Technical Service Information

THM 3L80 (400) VALVE BODY GASKET CHANGE

Figure 1

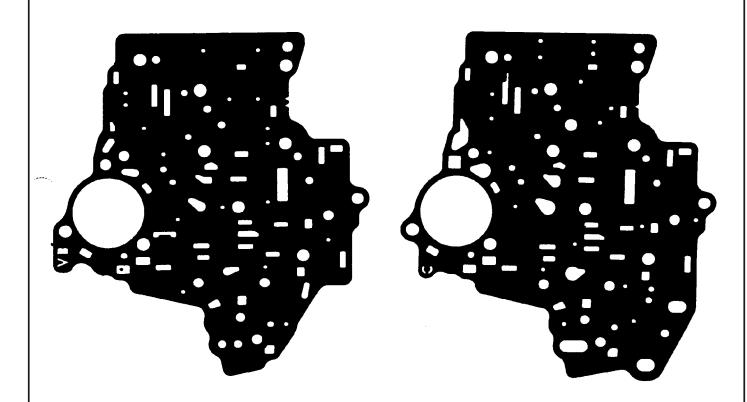
Beginning November 23, 1987, all TH400 transmissions were built, with new valve body gaskets. (SEE BELOW) This change and additional changes done to the case, valve body, and separator plate, were done to relieve a harsh park/neutral to reverse engagement shift feel.

8670447
SEE BULLETIN 88-33 FOR CASE AND SEPARATOR PLATE DIFFERENCES.
